Product Change Notification / MFOL-28NMYX712

CCB 5167 Final Notice: Qualification of MMT as an additional assembly site for selected MCP2561 and MCP2562 device families available in 8L DFN (3x3x0.9mm) package.

Pre and Post Change Summary

Lead Frame Comparison

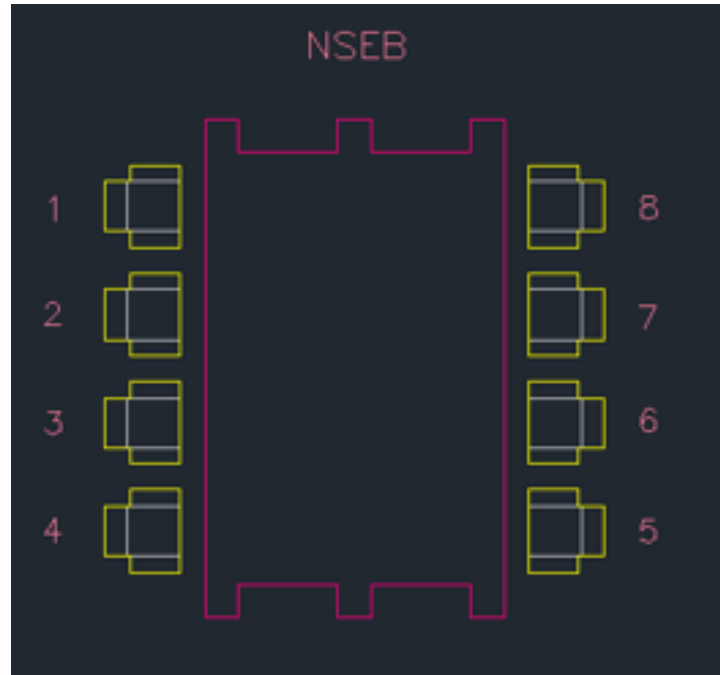
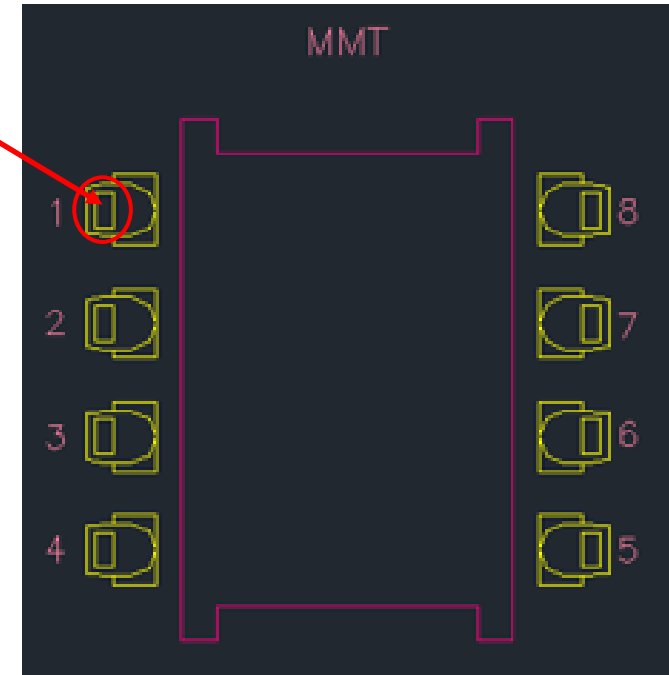
NSEB

Lead-lock

No

MMT

Lead-lock

Lead-lock

Yes

Note: Mold compound material fills the lead-lock hole, which provides improved protection against moisture penetration along the edge of the leads (pins) of the package.
